# DEVELOPMENT REVIEW COMMITTEE (DRC) COMMENT REPORT

**PROJECT NAME:** 745 N. Andrews

**CASE NUMBER:** UDP-S22027

**REQUEST:** Site Plan Level II Review: 220 Multifamily Residential Units and 5,783 Square-Foot of Commercial Use in the Northwest Regional Activity Center

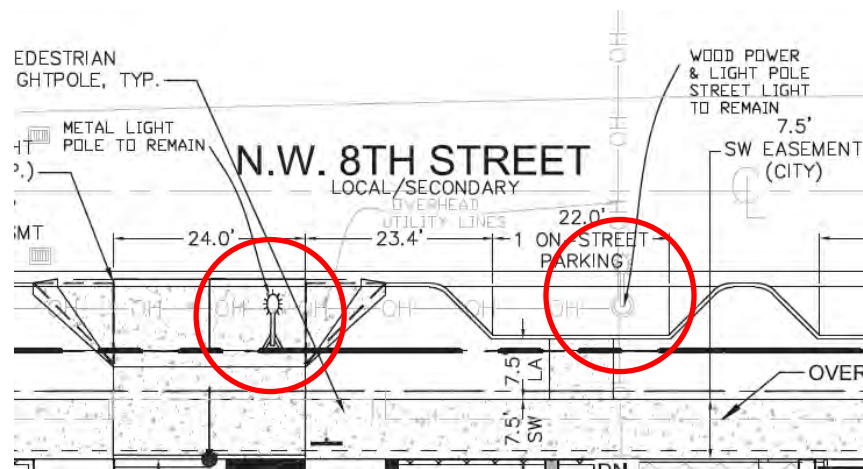
16. Revise the on-street parking adjacent to the driveway and the garage driveway which are currently obstructed by light poles that are labeled “to remain”. On-street parking should be removed at this location and the driveway revised. Please see below for reference.
